ADDENDUM # 1

Solicitation Number: 19-1233

Title: Building 49 – Upgrade Chilled Water System - CEF (19-1233)

Date: November 12, 2019

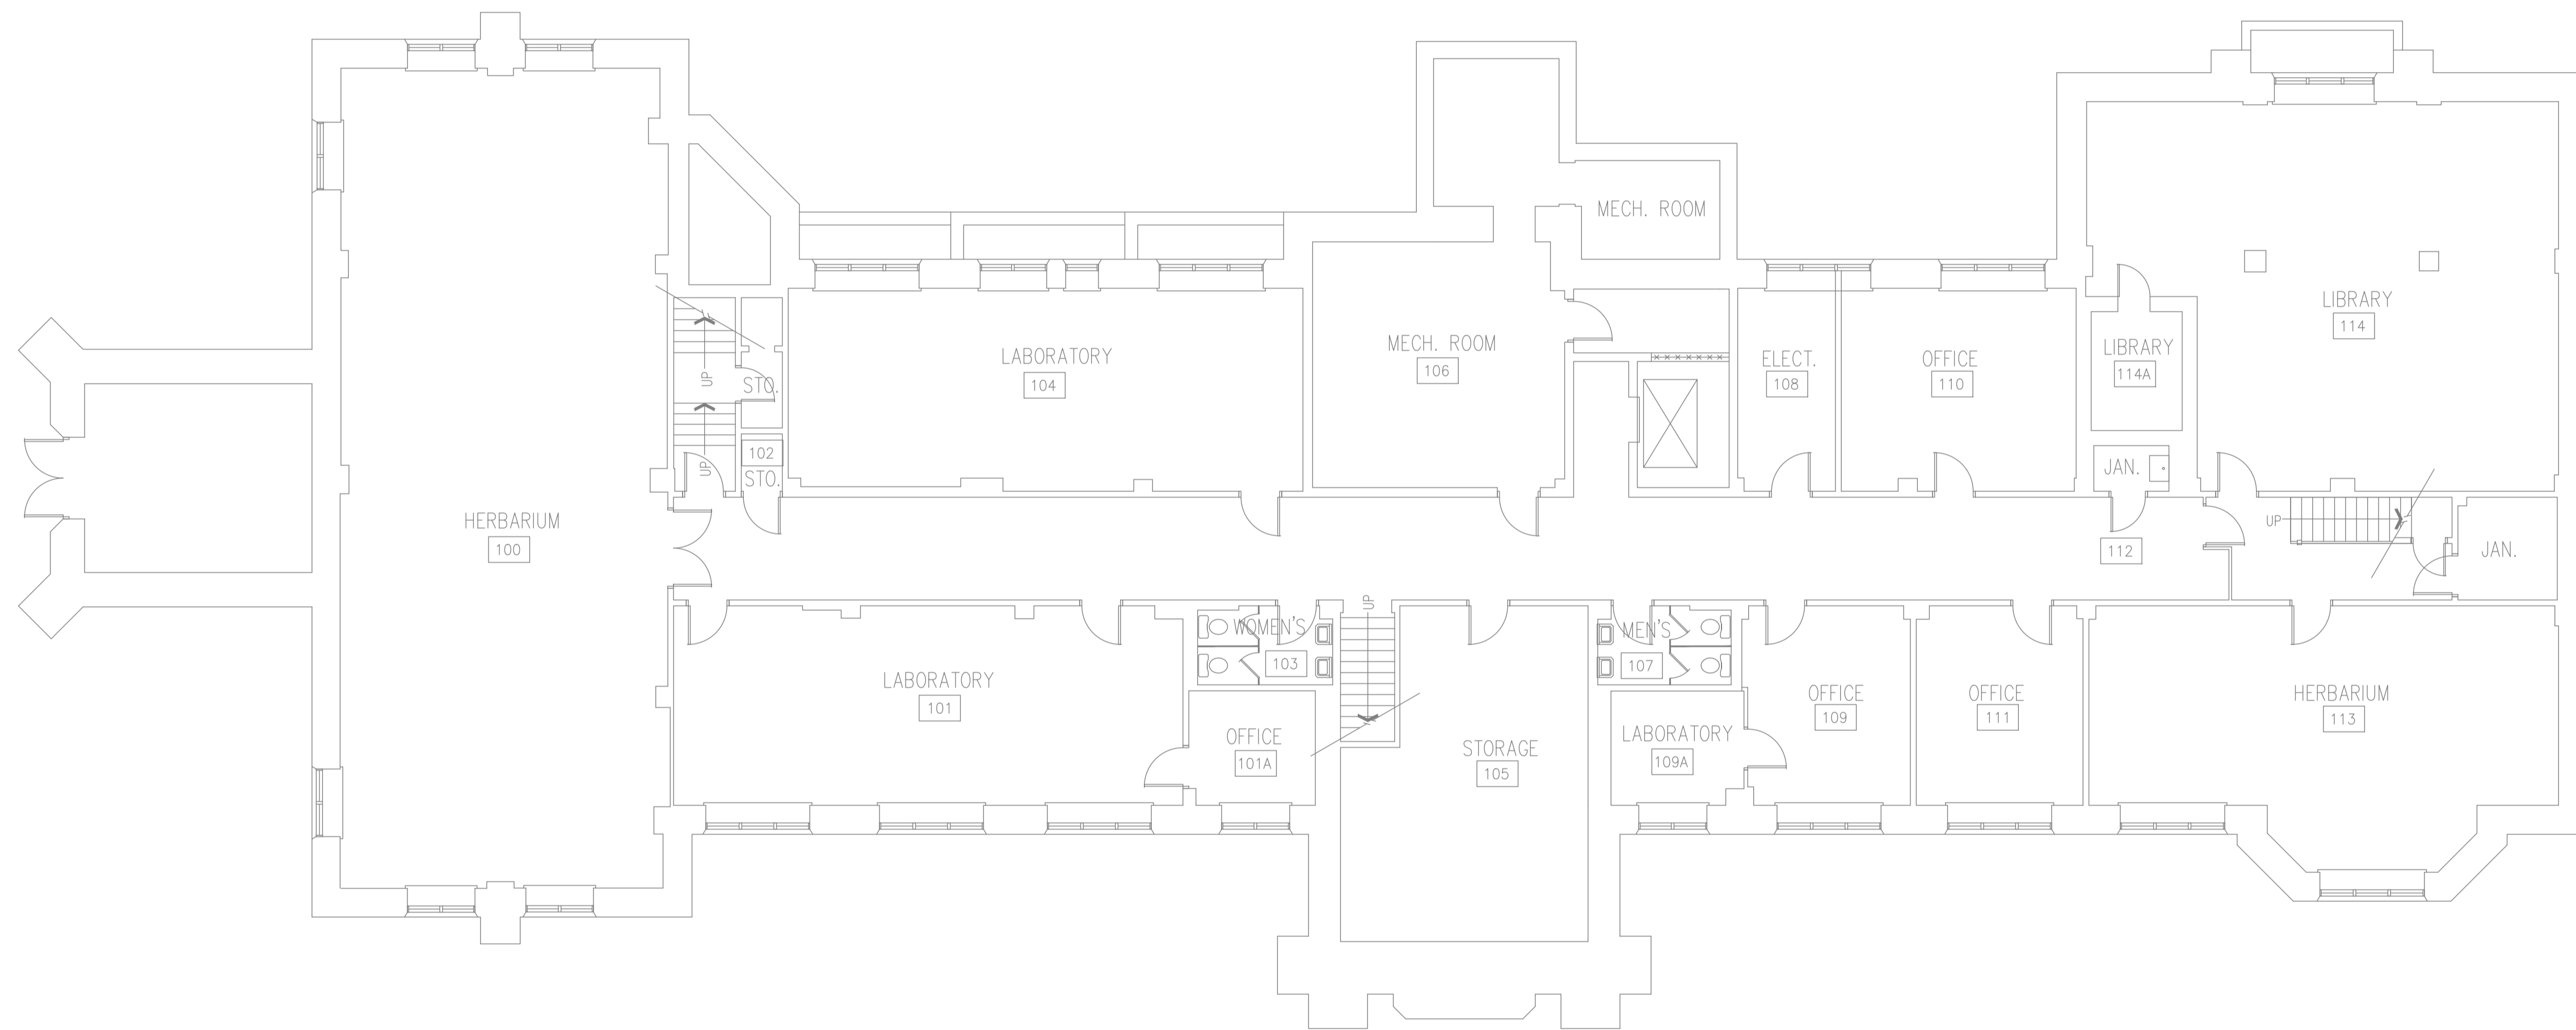
Q 8. Would it be possible to provide us with a length from the distribution panels (P-B) to the equipment that require new conduit and wire or a complete floor plan that we can measure the distances? Mechanical drawings are not sufficient for this missing information.

Q 9. Drawing E-2 shows a new connection to new chiller. Please provide the feeder distance from the chiller to the new 600a splitter in the main electrical room or supply a complete floor plan that we can measure the distances.

A 8. Please see building floor plans below for reference.

A 9. Please see building floor plans below for reference
